Service Information

Published by
The M.G. Car Company Ltd.
Abingdon-on-Thames

INDEX (Sheet 1)

Service Information Sheet No. 56**OIL LEAKING INTO CLUTCH**

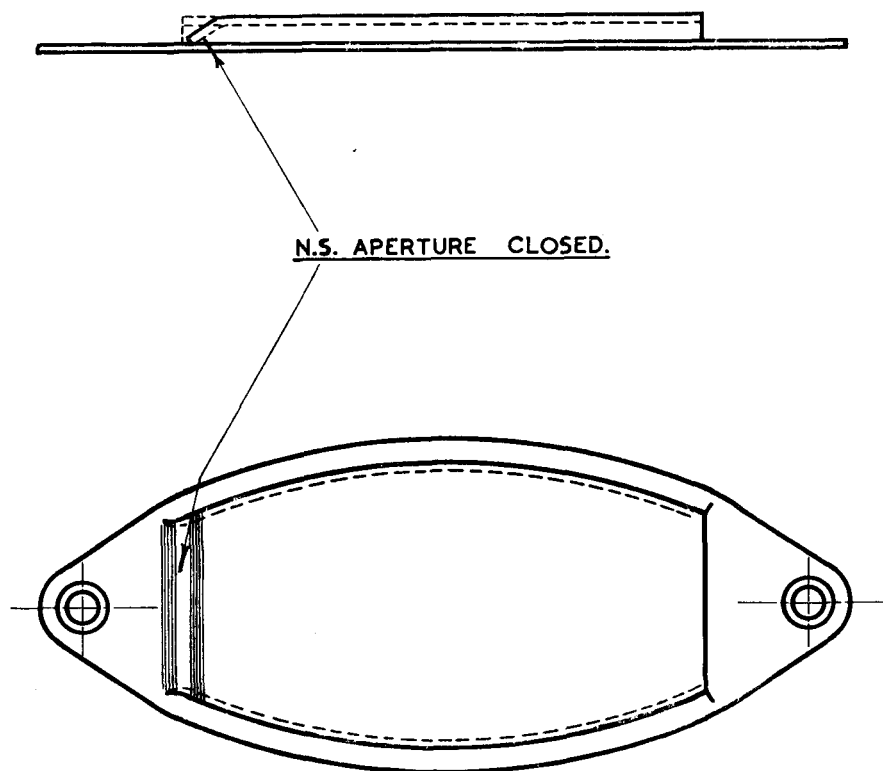
1. A cover must be fitted over the starter pinion. The first few engines were not fitted with them. The clutch housing must be drilled and tapped to receive the securing screws, the cover can be used as a template for marking the holes.

2. The clutch inspection cover was originally designed with two breather apertures, but the near-side aperture must be closed, it being necessary only to close this aperture by tapping with a ball pein hammer. The sketch below illustrates this particular point.

*Date of Issue : August, 1938***Service Information Sheet No. 57****OIL LEAKING FROM THE REAR AXLE NOSEPIECE**

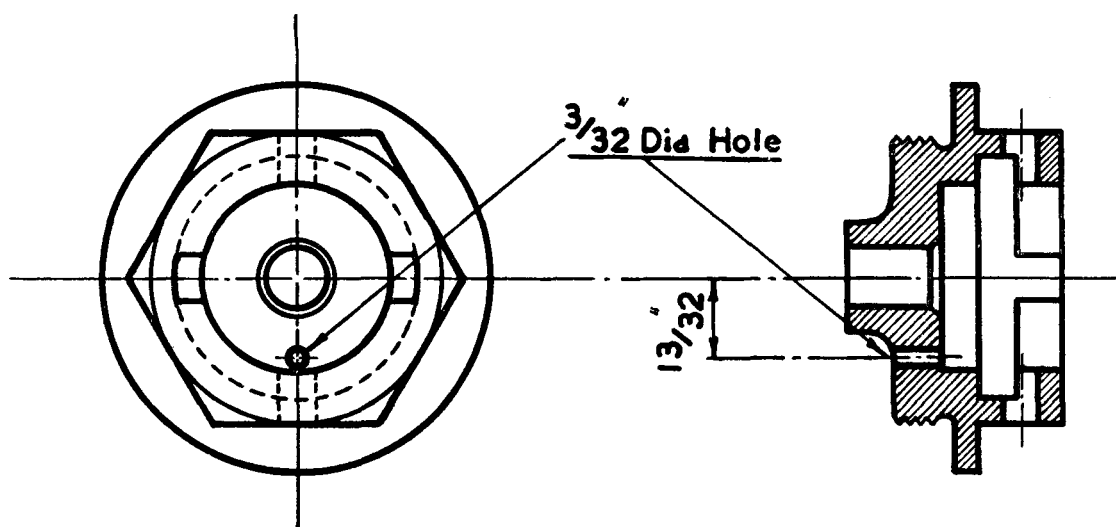
The breathing of the axle is intended to operate between the oil level dipstick and its housing, a definite clearance being given for this purpose. Due to small variations between the size of the hole and the size of the dipstick this clearance under extreme conditions proving inadequate and an additional $\frac{3}{32}$ " dia. hole has been made in the dipstick carrier or filler plug in the position illustrated by the sketch.

Service stations are advised, therefore, that if this difficulty is experienced this hole should be drilled.

Service Information Sheet No. 59**LUBRICATION OF THE KING PINS**

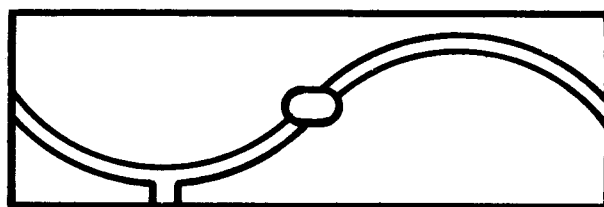
The king pin bushes for the above models have been modified to give more efficient lubrication of the king pins. The oil grooves are designed to lubricate the thrust surfaces also, and it must be noted, therefore, that there is a correct method of fitting the bushes to the stub axle. The same remark applies to both top and bottom bushes.

The sketch below illustrates the modified groove, and it is essential that the bush is fitted so that the oil leak is towards the axle beam.

It should be noted that when the new bushes are pressed into place, it is necessary to use a spiral reamer of sufficient length to do both bushes at the same time.

Service Information Sheet No. 60**METHOD OF CLAMPING REAR HUB BALL RACE**

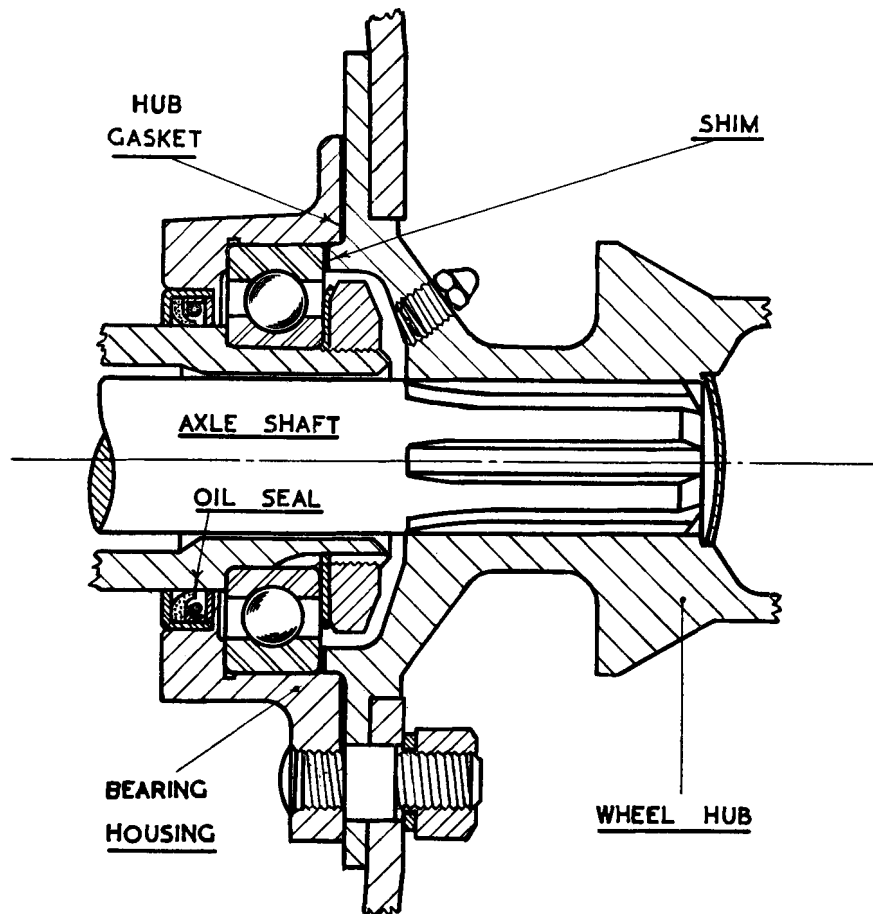
A gasket has been introduced between the rear hub and bearing housing to ensure an oil-tight joint.

In certain circumstances, due to machining limits, the introduction of this gasket gives a clearance between the ball race and the dowel of the hub, which allows the bearing housing to float on the ball race. To overcome this a shim should be fitted as illustrated in the sketch below. SA. Type Two-Litre Shim .010 in. (Part No. MG663/157), and TA. Series Midget and VA. Type 1½-Litre Shim .007 in. (Part No. MG689/143).

Service Information Sheet No. 62**STEERING SWIVEL PIN THRUST ARRANGEMENT**

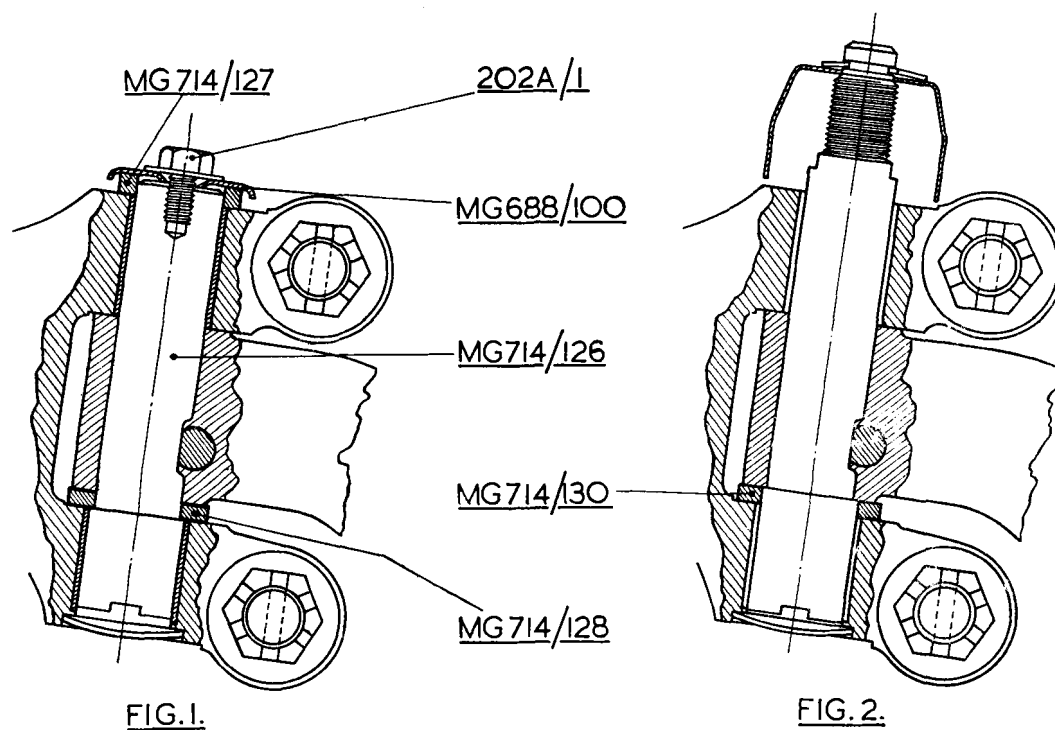
Commencing Chassis No. VA1254 a modification was introduced to the thrust arrangement of the steering swivel pin, the ball thrust race being superseded by a bronze thrust washer.

- (a) The swivel pin was replaced by one which has its largest diameter shortened to accommodate a thrust washer, and, instead of a threaded portion to secure the ball race, is drilled and tapped to take a bolt to secure a felt washer and cover for dirt exclusion.
- (b) A bronze thrust washer.

Reference to Fig. 1 will illustrate this assembly.

To cars having a chassis number prior to VA1254 the above modification can be carried out by fitting the new type swivel pin, thrust washer, felt washer, cover-plate and bolt, all other parts being unaltered.

An alternative method (Fig. 2) enables a slightly modified thrust washer to be fitted to the original swivel pin. This modified washer, Part No. MG714/130, has a larger inside diameter to fit over the largest portion of the original type swivel pin. The ball race must be discarded, but the ball race dust cover and horse-shoe clip is refitted for appearance's sake.

Service Information Sheet No. 63**FAN BELT ADJUSTMENT**

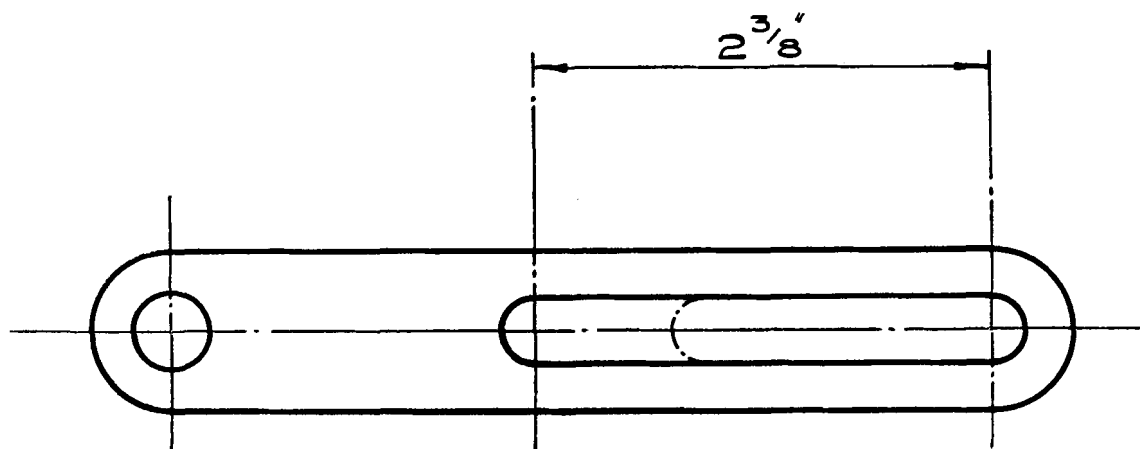
To provide a greater range of adjustment to the dynamo for adjusting the fan belt, a shorter belt is now being fitted. As the new type belt will be supplied for service replacement, it will be necessary to lengthen the slot in the dynamo support, otherwise the belt will be too tight when first fitted. The alteration necessary to the support is illustrated in the sketch below.

*Date of Issue: September 1938***Service Information Sheet No. 65****ALTERATION TO SILENCER FLANGE**

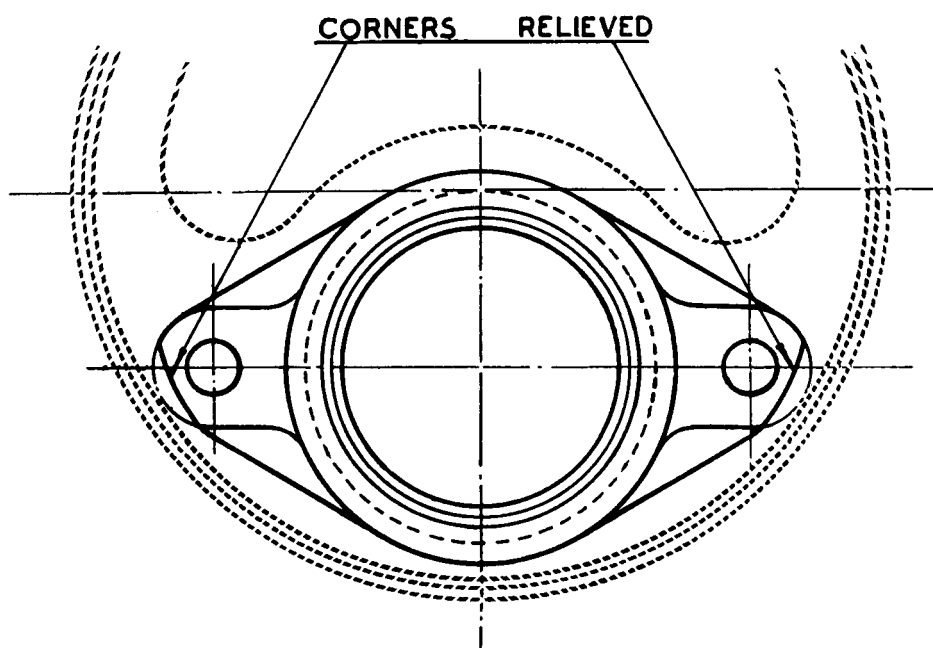
With the introduction of a slightly smaller diameter silencer on the Two-Litre model, it should be noted that, when fitting the new silencer as a replacement on the earlier cars, it will be necessary to relieve the corner of the exhaust pipe flange as illustrated.
